**Fenwick Solar Farm
EN010152**

**Landscape and Visual Supplementary Report
Document Reference: EN010152/APP/8.23**

- 1.1.1 Iceni Projects (Iceni) have prepared this Landscape and Visual Supplementary Report in response to the Relevant Representation made by City of Doncaster Council (CDC) **[RR-001]** (CDC's Relevant Representation) in relation to the proposed Fenwick Solar Farm (the Proposed Development). This was informed by a review of the Landscape and Visual Impact Assessment (LVIA) which was carried out by LUC on behalf of CDC.

Appendix A - Updated Figure 10-9: Representative Viewpoint Locations [APP-111]

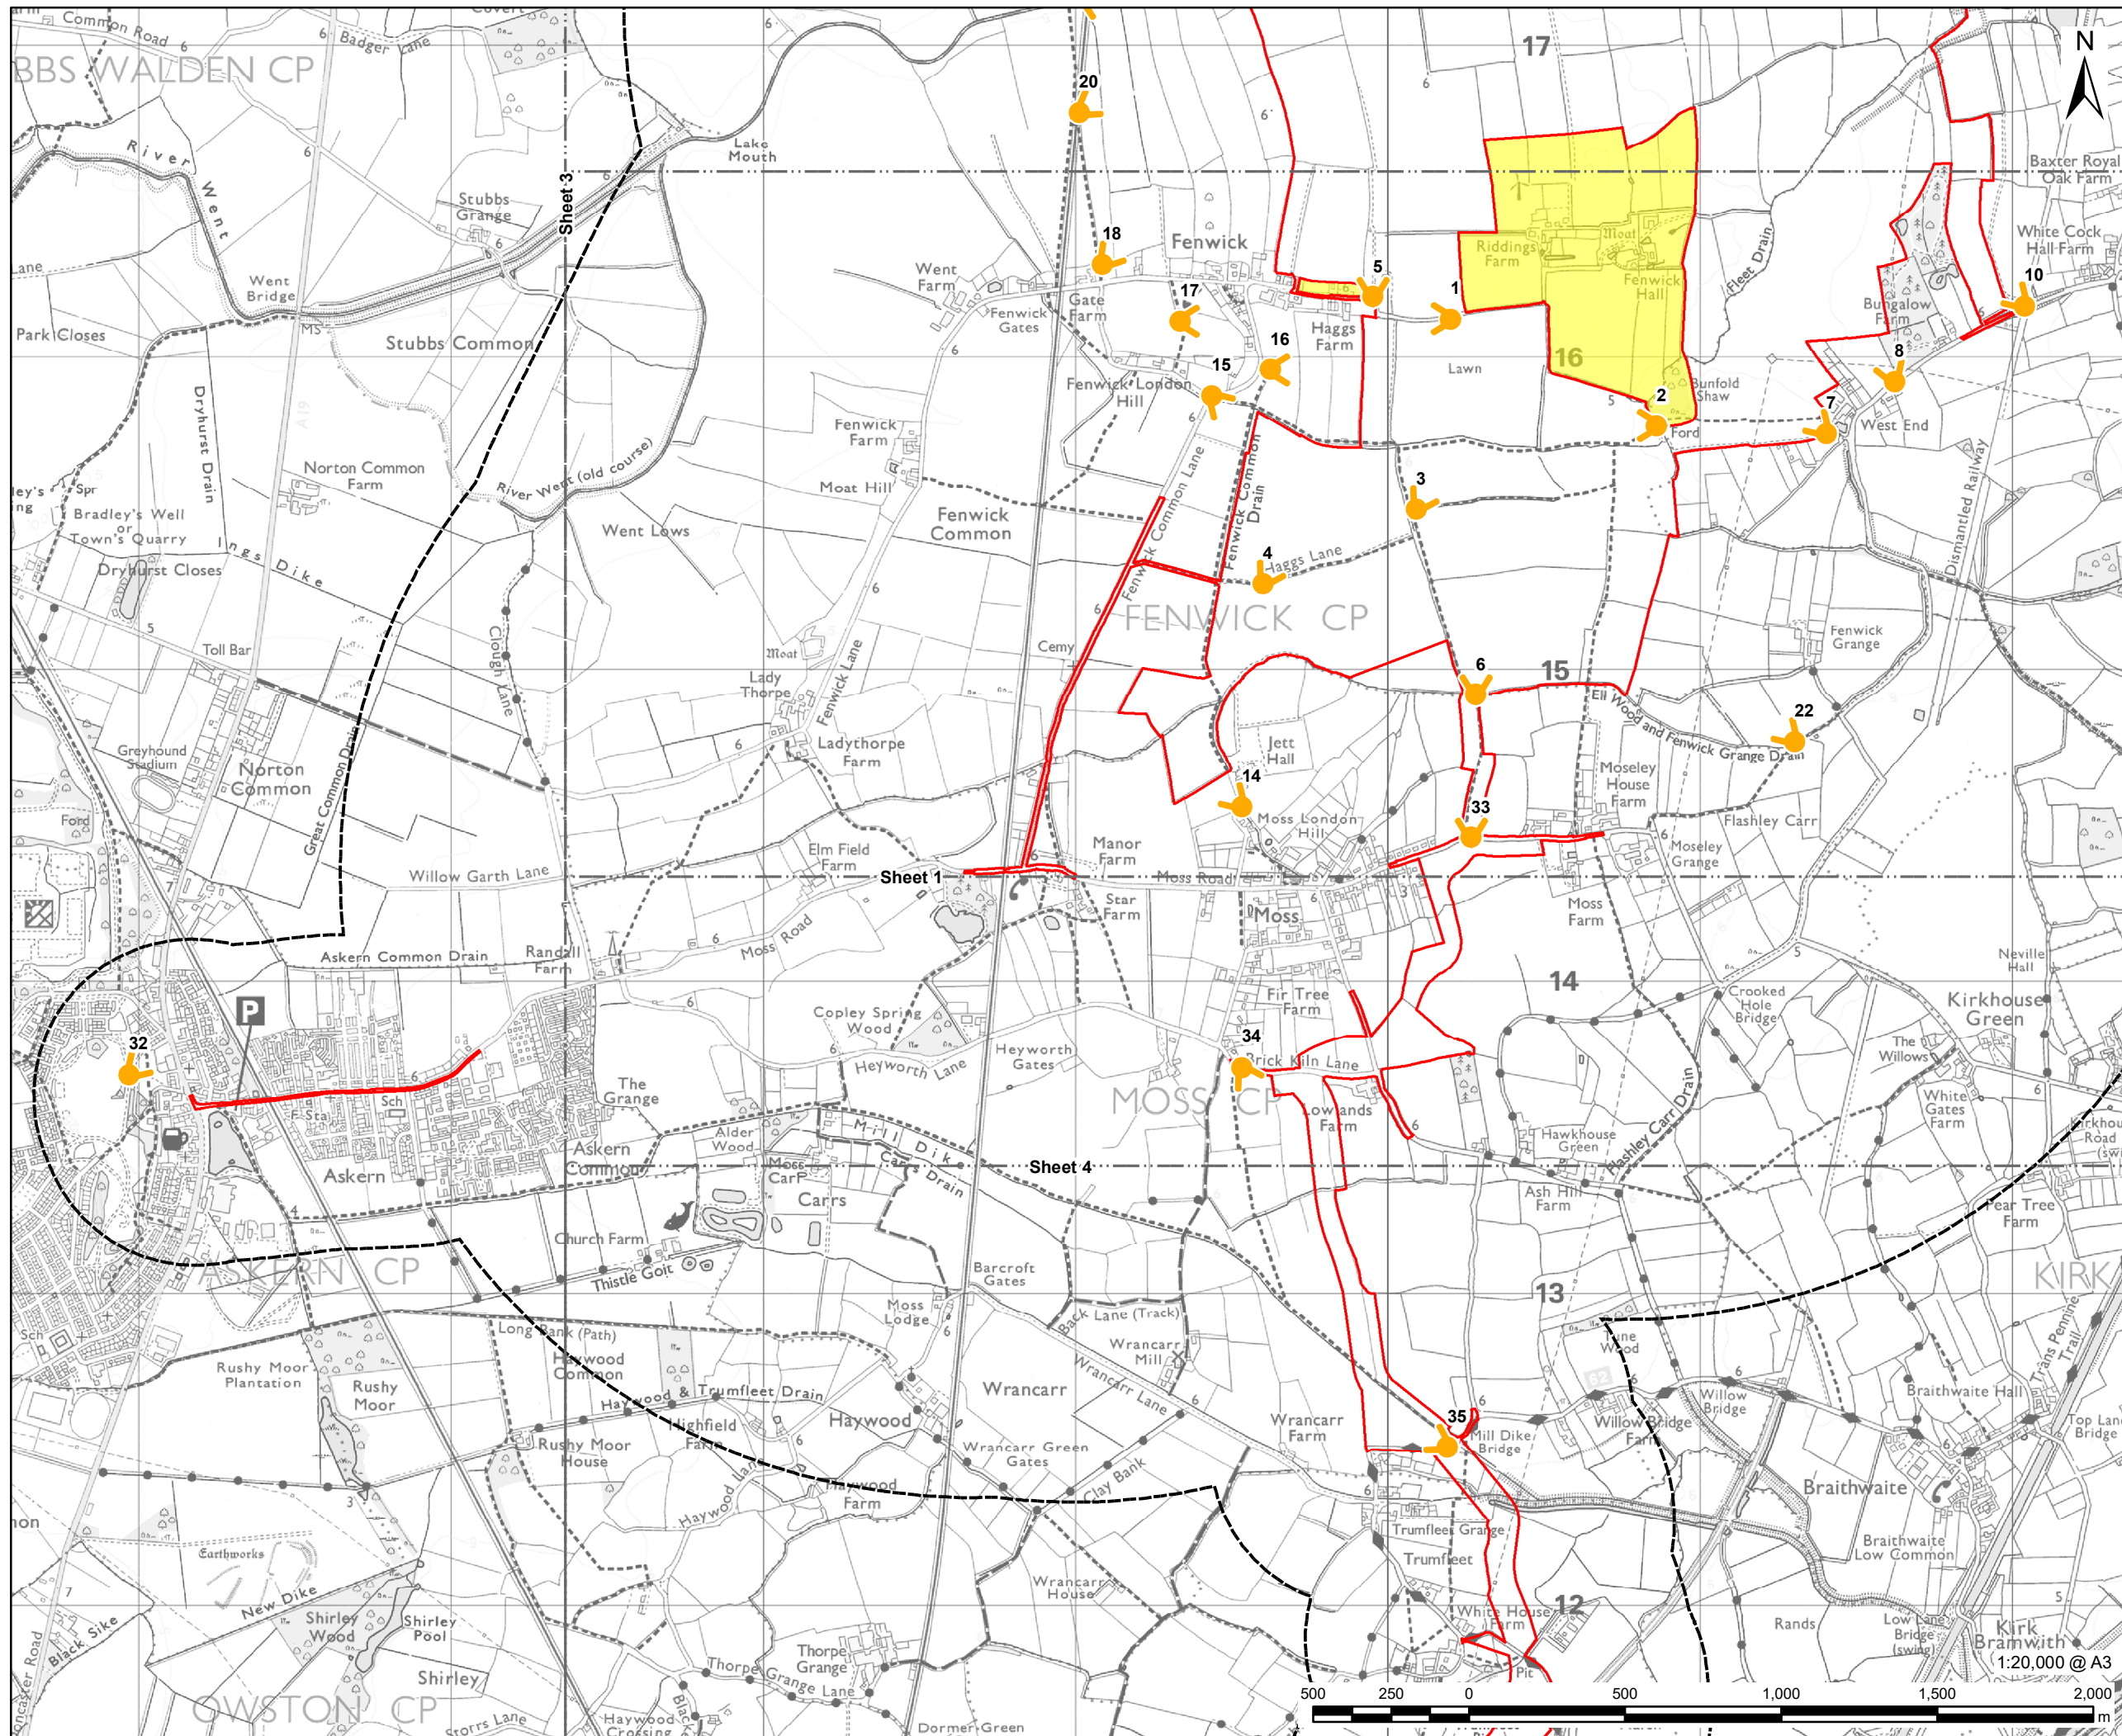
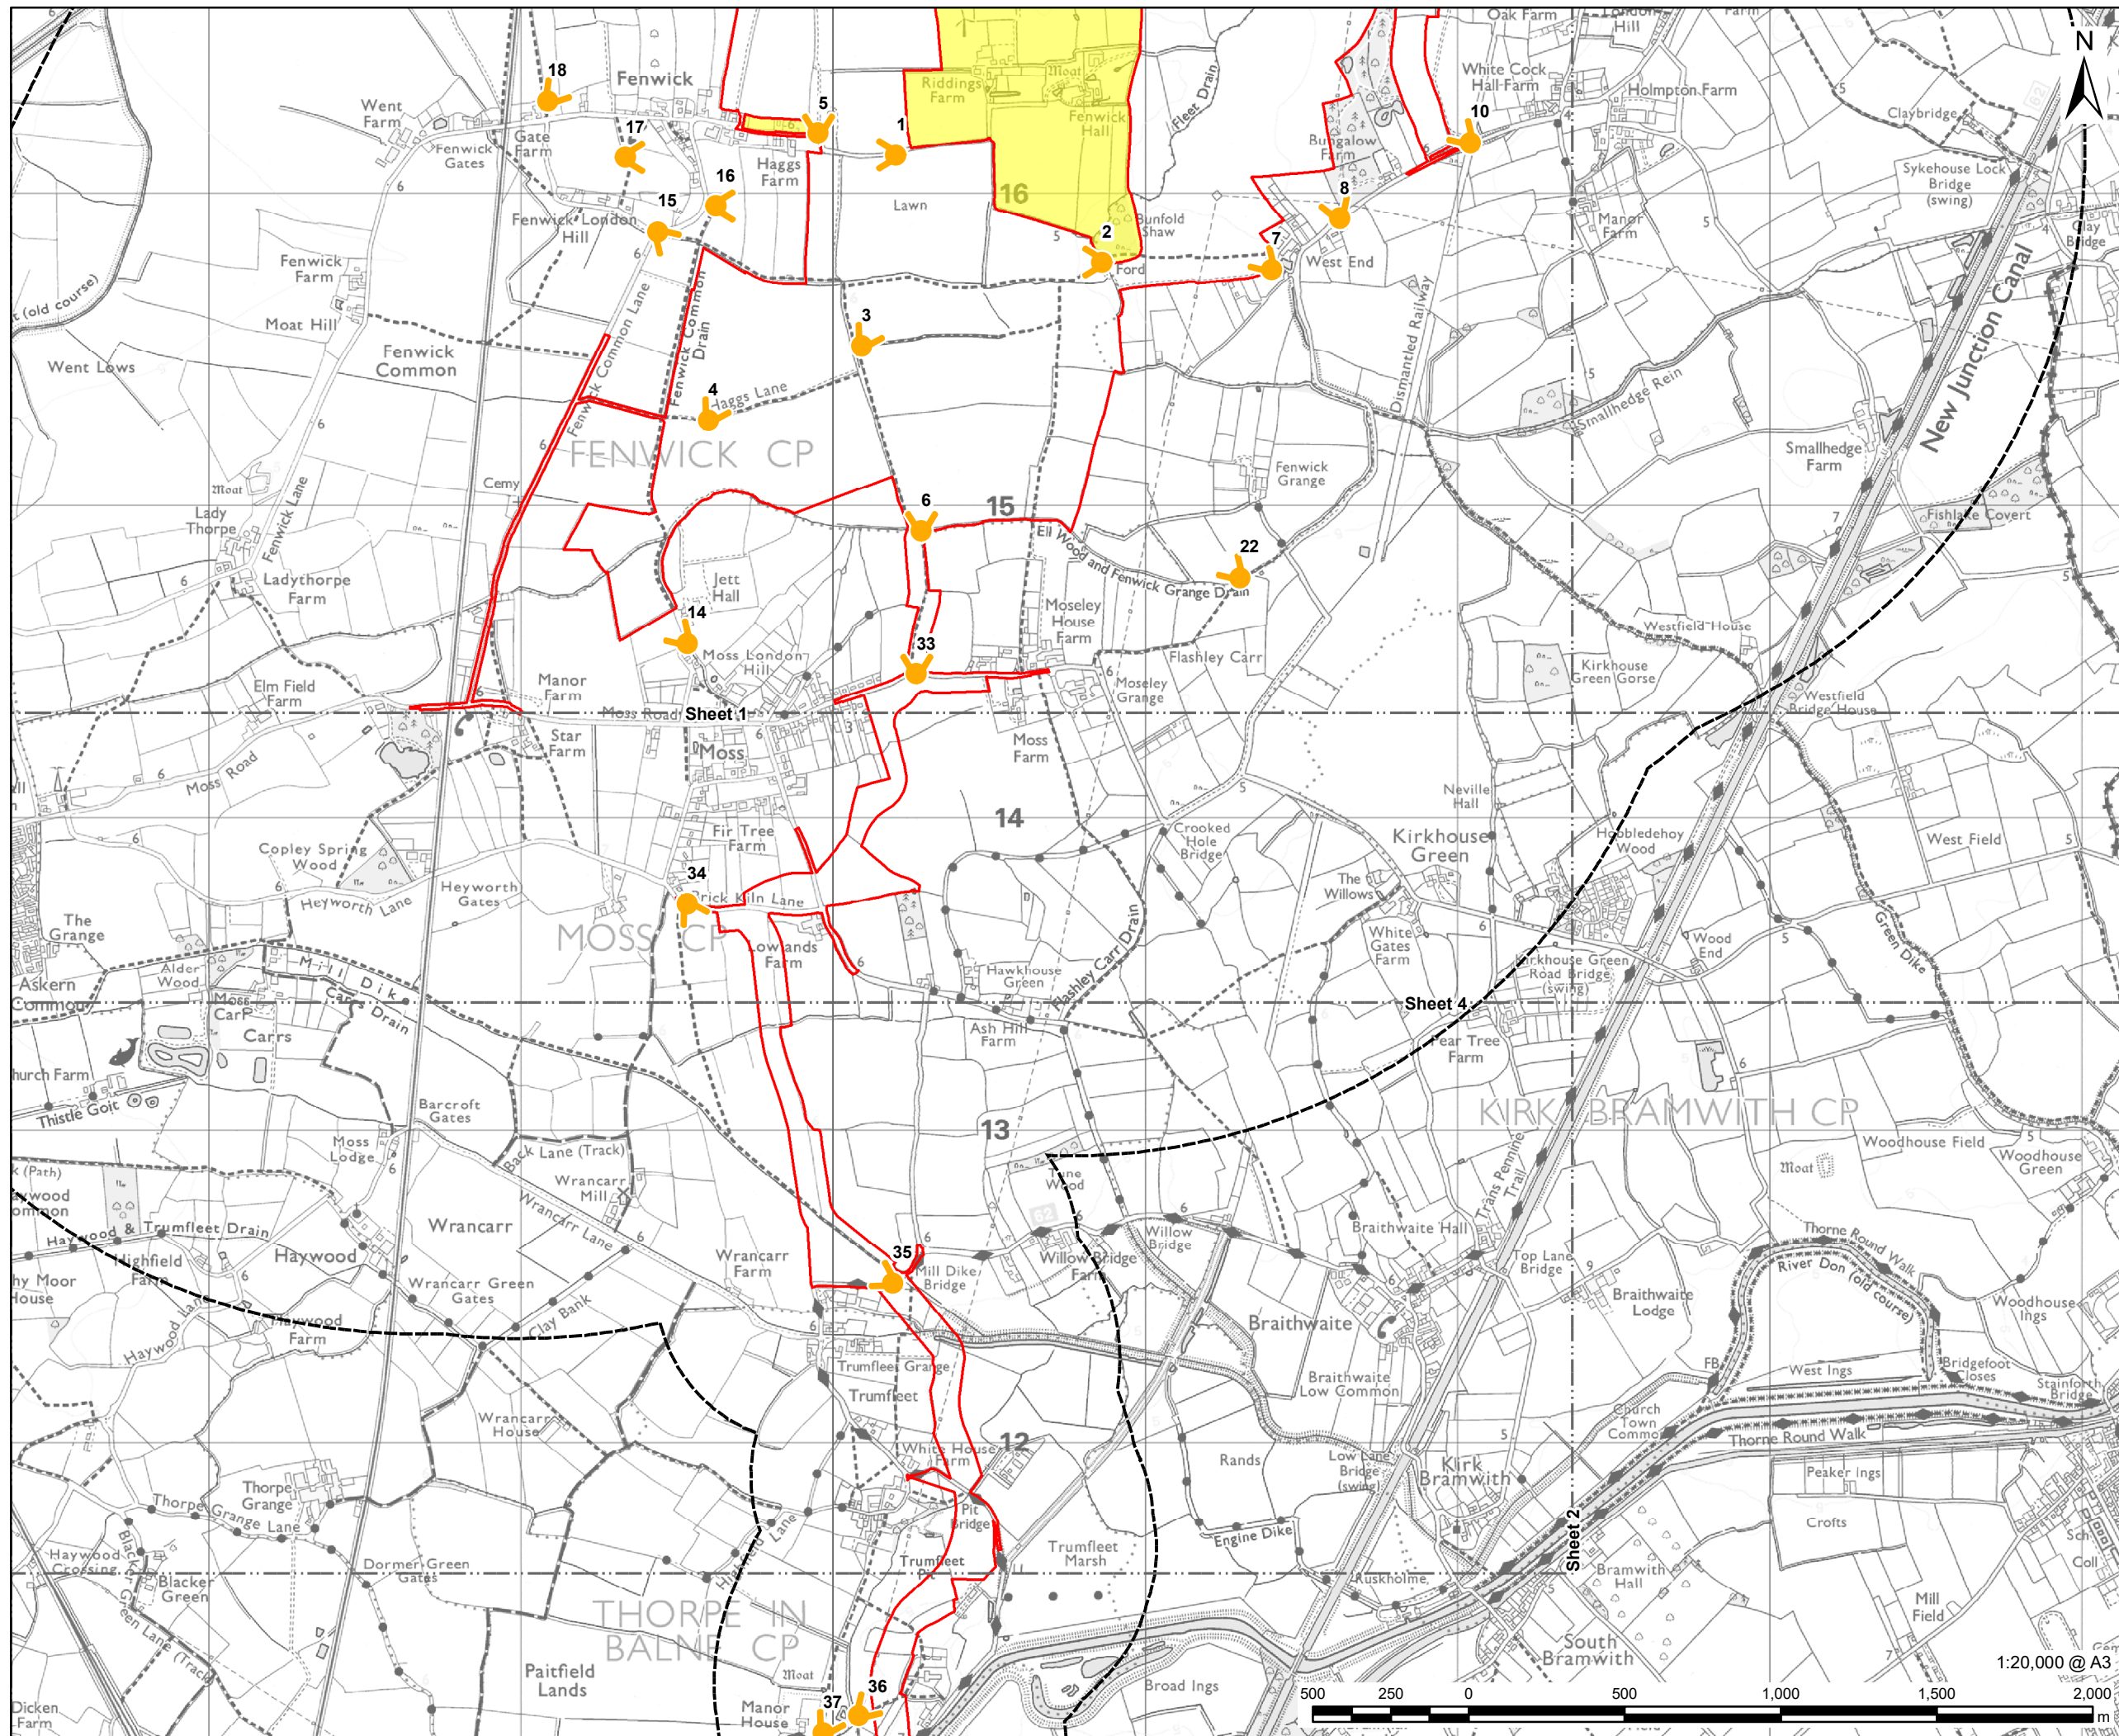
- Updated representative viewpoint plan (**ES Volume II Figure 10-9: Representative Viewpoint Locations [APP-111]**) with clearer base mapping;
- Detail of updates to be made to the Zone of Theoretical Visibility (ZTV) (**ES Volume II Figures 10-6 – 10-8 [APP-108 – APP-110]**);

- 2.1.4 An updated representative viewpoint plan has been provided within **Appendix A**. This has been split across four sheets, using 1:25,000 OS base mapping. The 1:25,000 OS base mapping does not yet show the new properties along Fenwick Common Lane / Shaw Lane. However, these are included on the 1:10,000 mapping used as thumbnails to present the location of each representative viewpoint alongside the updated viewpoint photography photosheets (to be provided in early to mid-May).
